Land at Chesapeake, Sayers Common: Transport Statement Addendum

Ref: TW/BB/ITB200420-004A TN
Date: 11 December 2025

Image 3.1: Proposed Additional Pedestrian Infrastructure Improvements

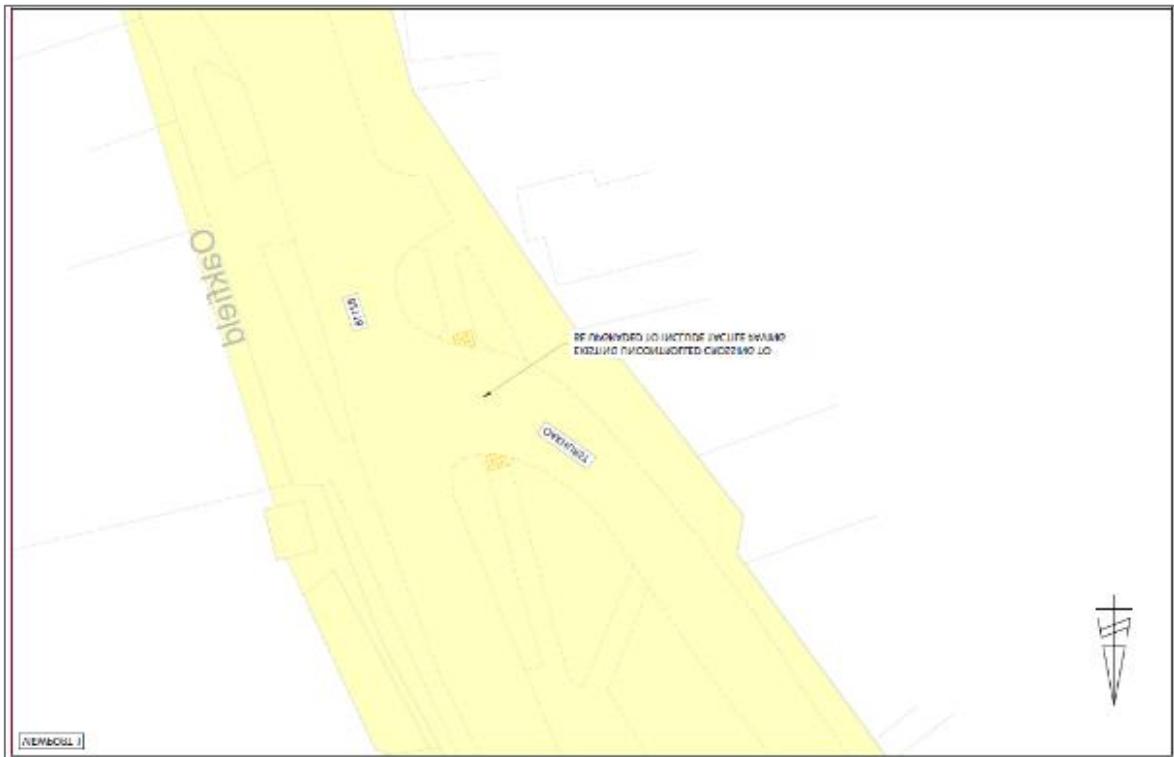
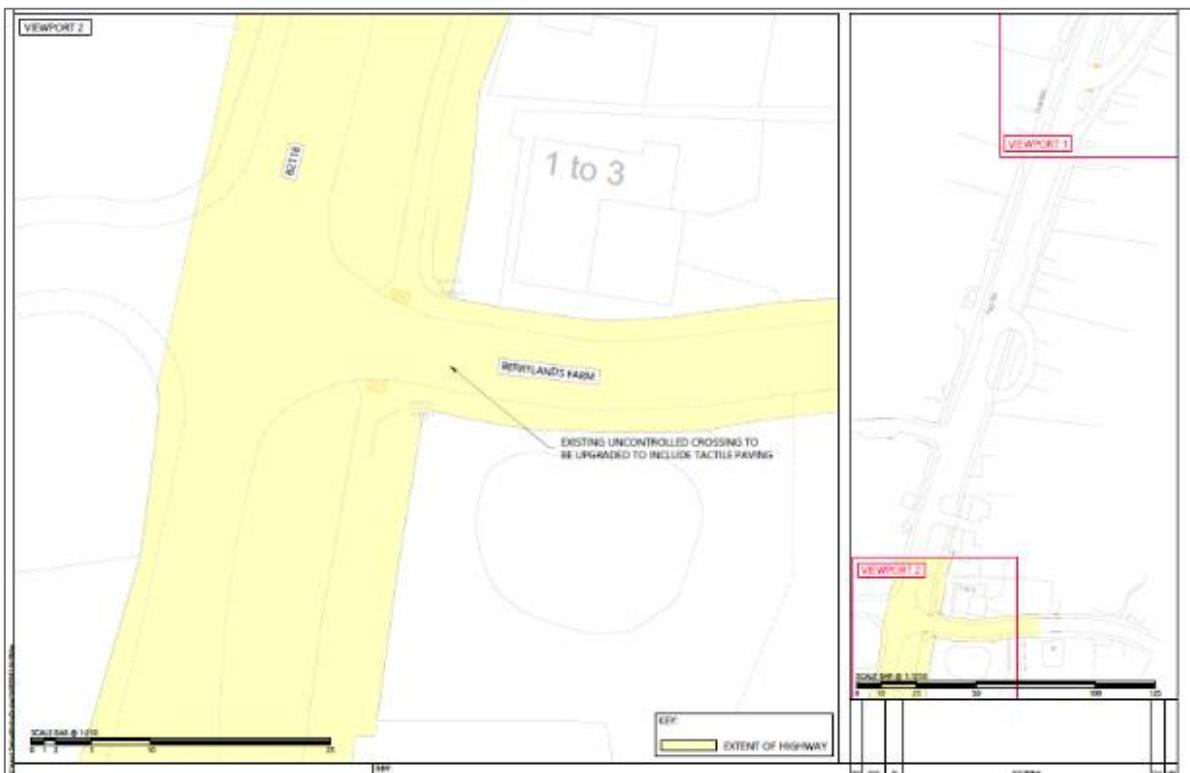
4.1.1 Within their consultation response, WSCC requested that additional pedestrian infrastructure improvements are delivered on the pedestrian desire line into Sayers Common village and the nearest bus stops on B2118.

4.1.2 Specifically, WSCC requested that the following additional improvements are delivered as part of the development proposals:

- 1 Upgrading the existing dropped kerb pedestrian crossing of Berrylands Farm to include tactile paving; and
- 2 Upgrading the existing dropped kerb pedestrian crossing of Oakhurst to include tactile paving.

4.1.3 In response to WSCC's comments, drawing **ITB200420-GA-008** presents an improvement scheme at the two identified pedestrian crossing points, confirming how these can be upgraded to include tactile paving. An extract of the drawing is presented as **Image 3.1**.

4.1.4 The applicant is willing to deliver these additional works as part of the development proposals, and these works can be secured through a Section 278 Agreement.

CLIENT: ANTLER HOMES
TITLE: PROPOSED OFF-SITE PEDESTRIAN INFRASTRUCTURE IMPROVEMENTS
PROJECT: LAND AT CHESAPEKE, SAYERS COMMON

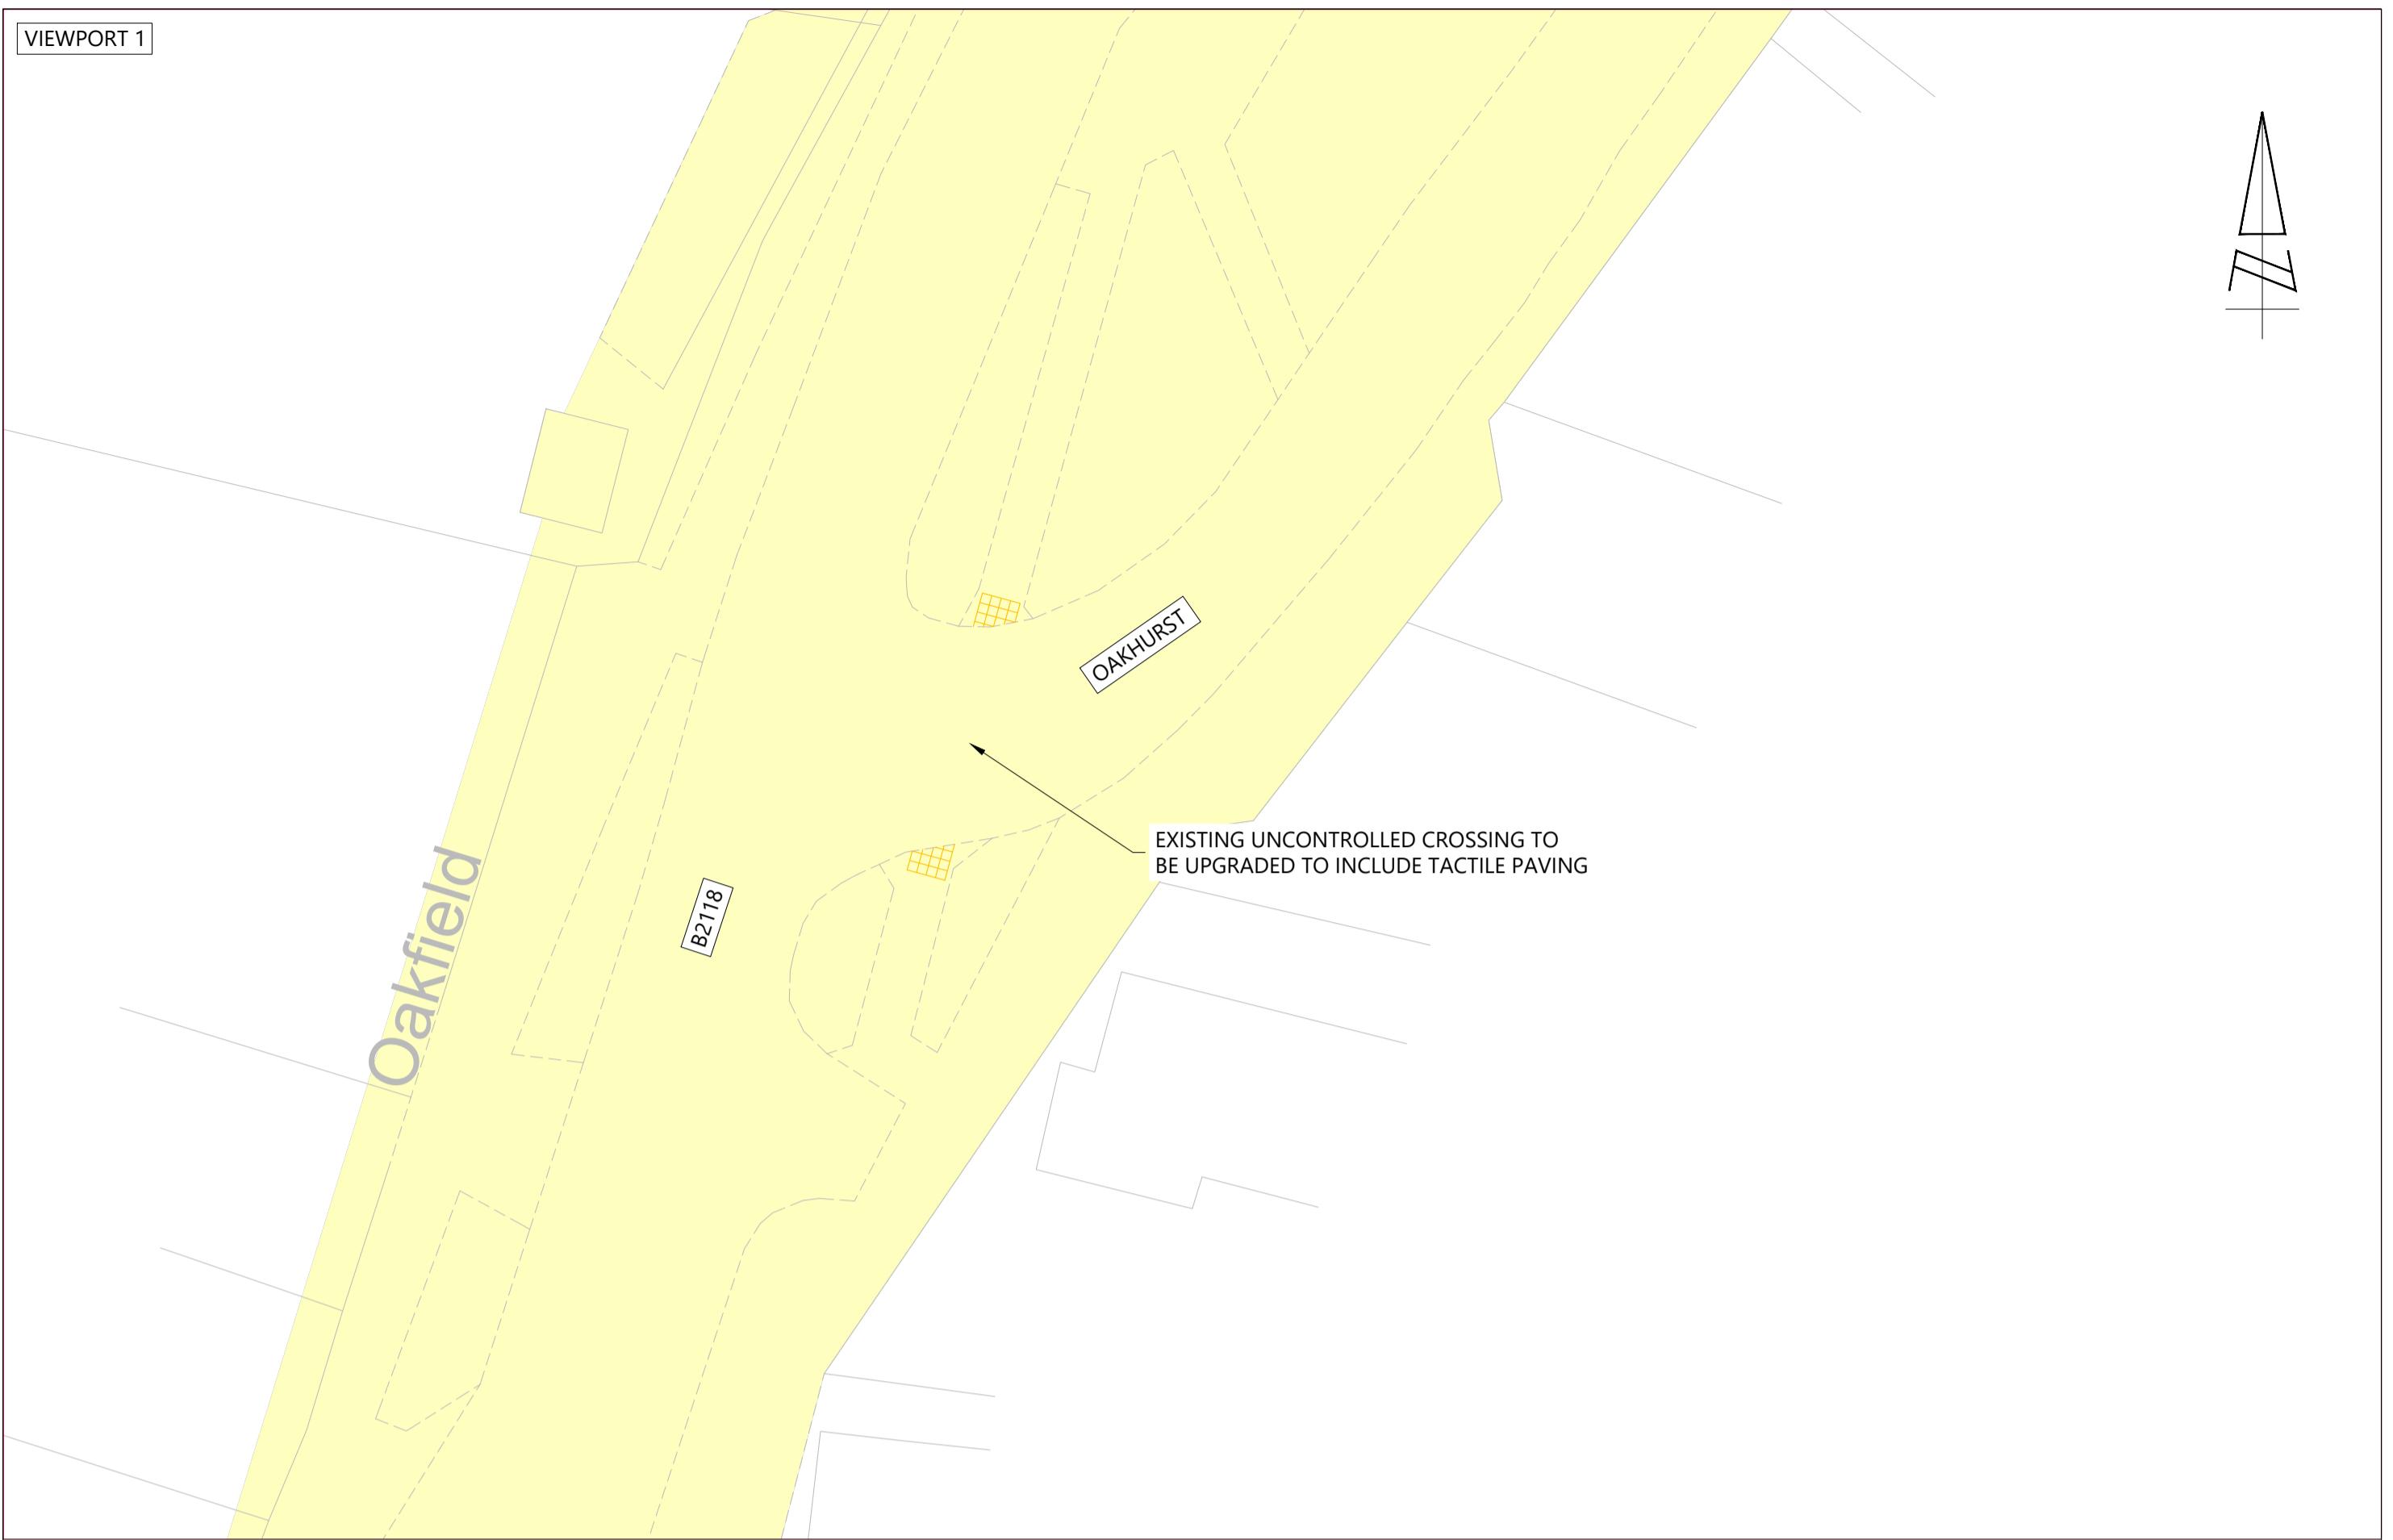
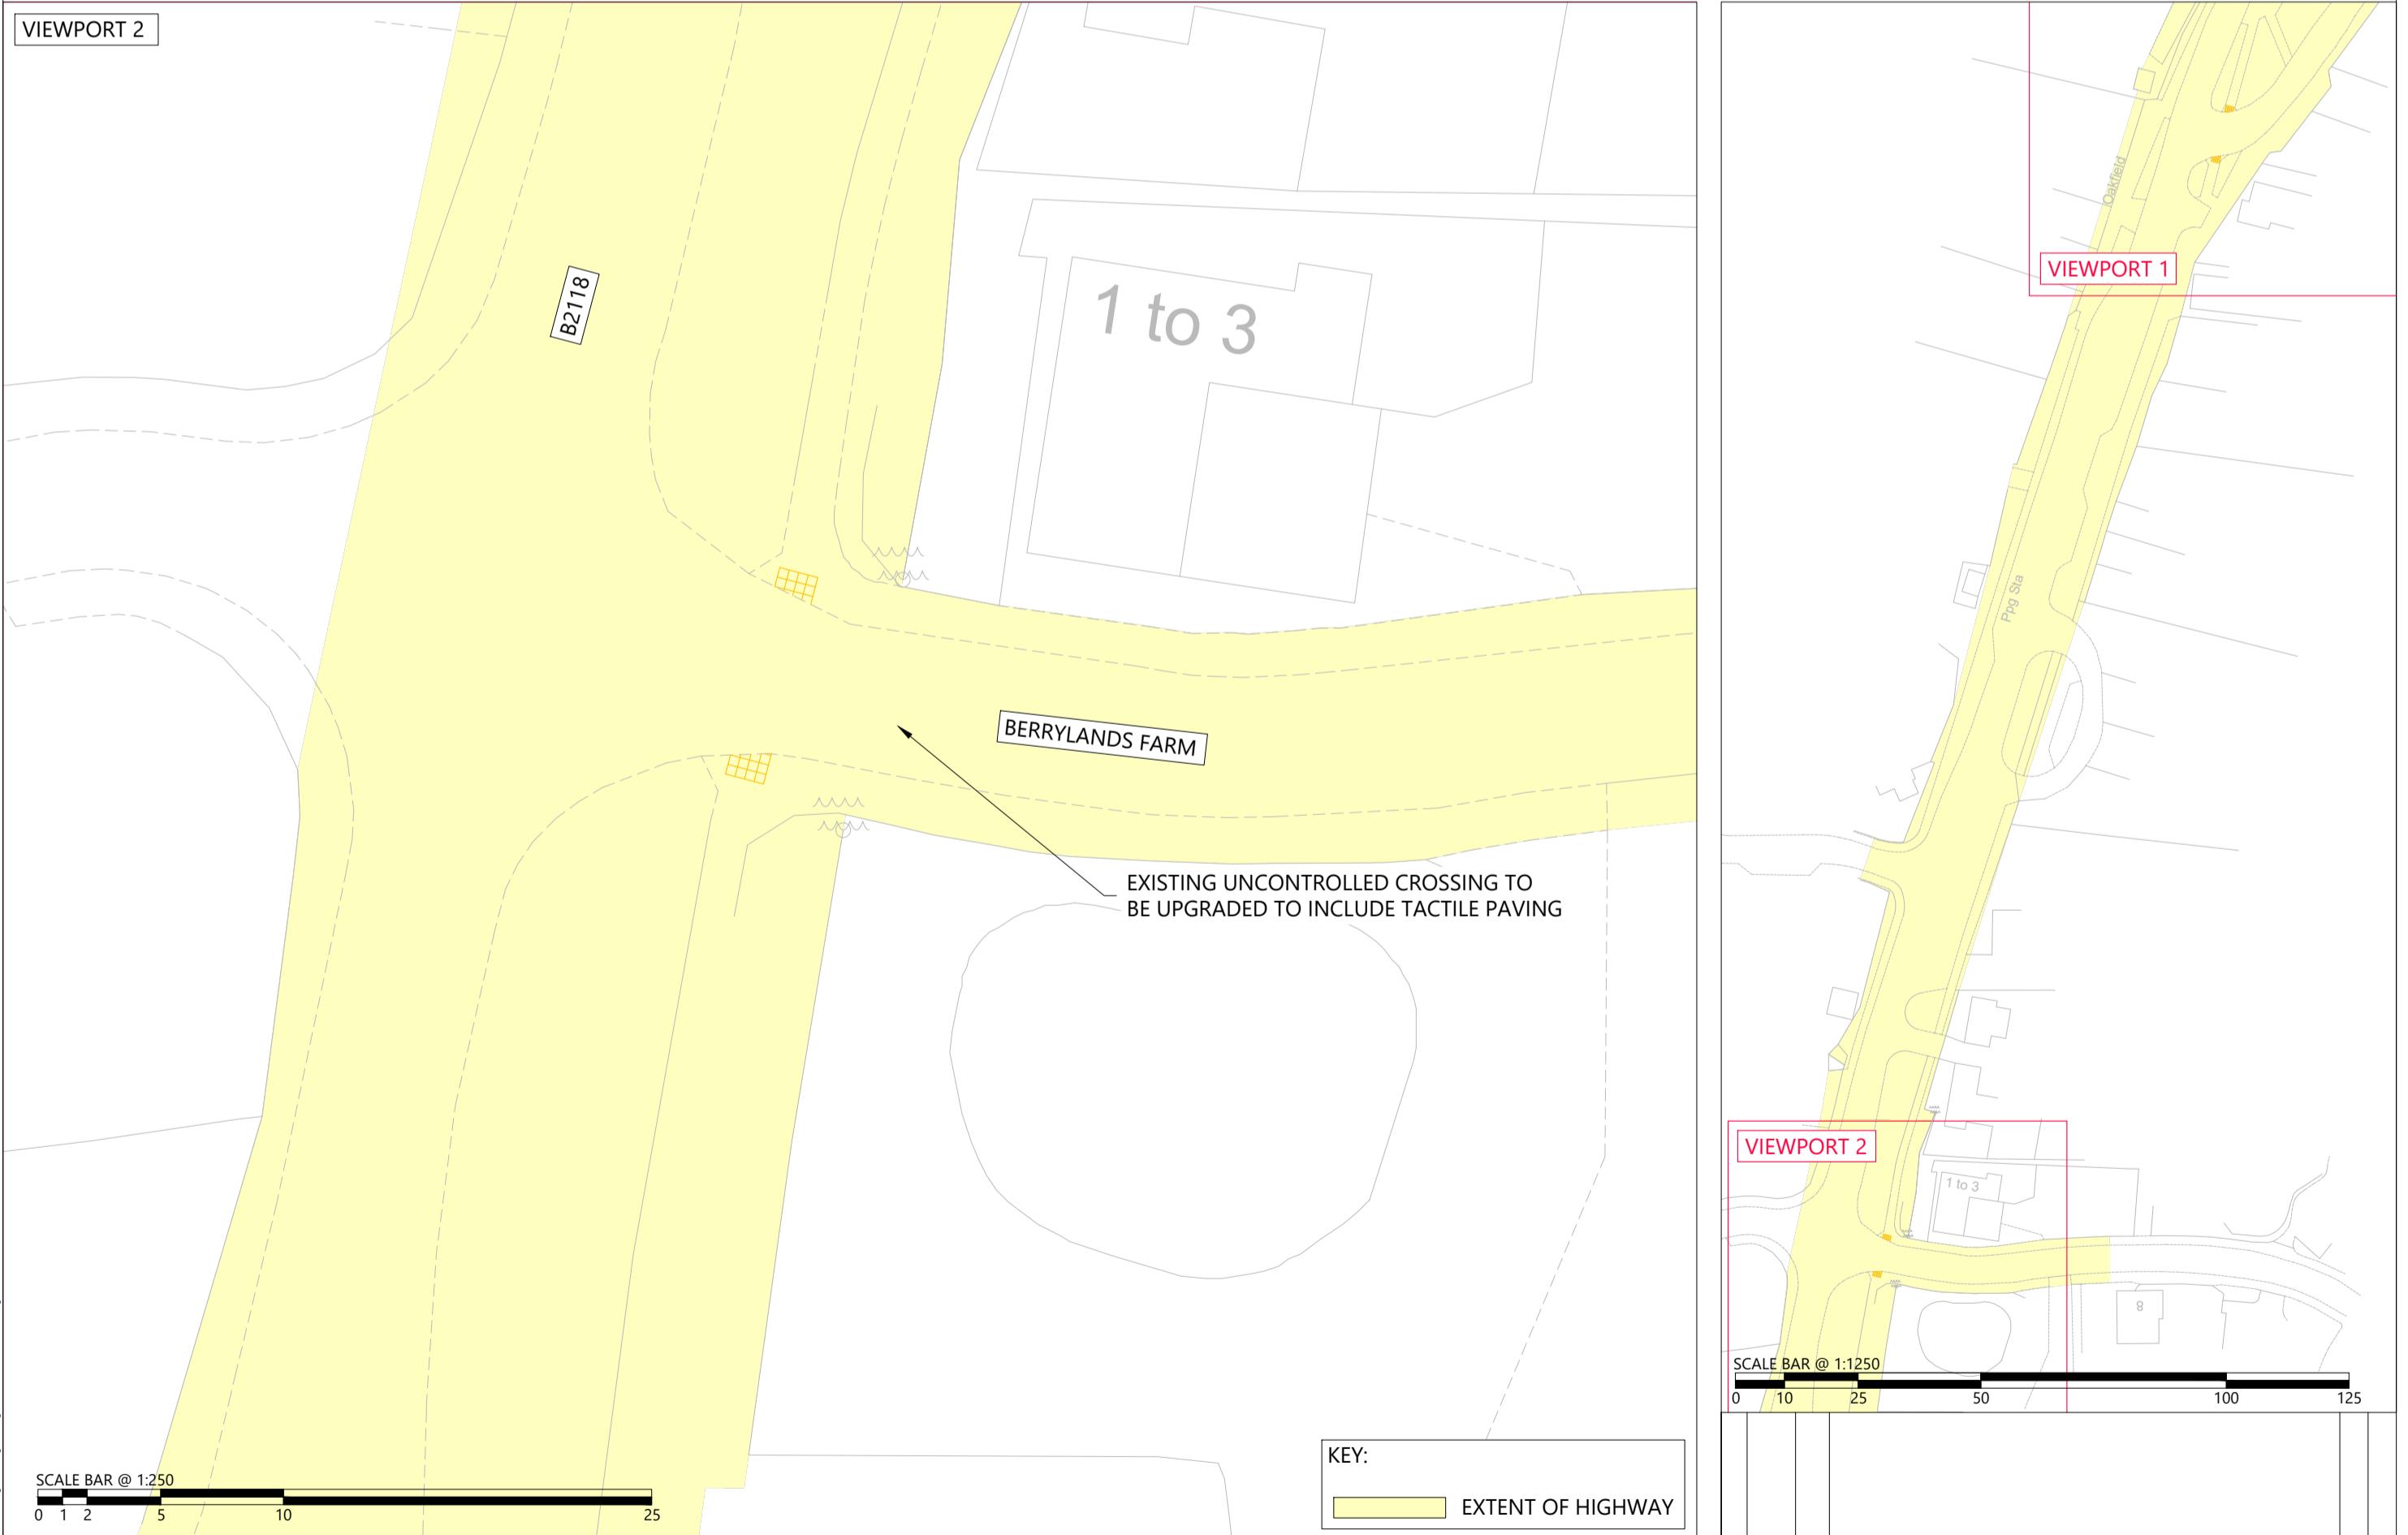
The LHA consider additional improvements could be made on the pedestrian desire line into village and nearest bus stops, namely:

- Tactile paving at existing dropped kerb crossing of Oakhurst
- Tactile paving at existing dropped kerb crossing of Berrylands Farm

It is considered that these improvements are required to *provide safe and suitable access for all users* (para. 115 National Planning Policy Framework - NPPF) ...*give priority to pedestrian movements...address needs of people with disabilities and reduced mobility in relation to all modes of transport* (para. 117 NPPF).

- 2 As set out in Section 3 of this report, the development proposals will deliver further off-site pedestrian infrastructure improvements at the existing Berrylands Farm and Oakhurst pedestrian crossing points. These works can be secured through a Section 278 Agreement.
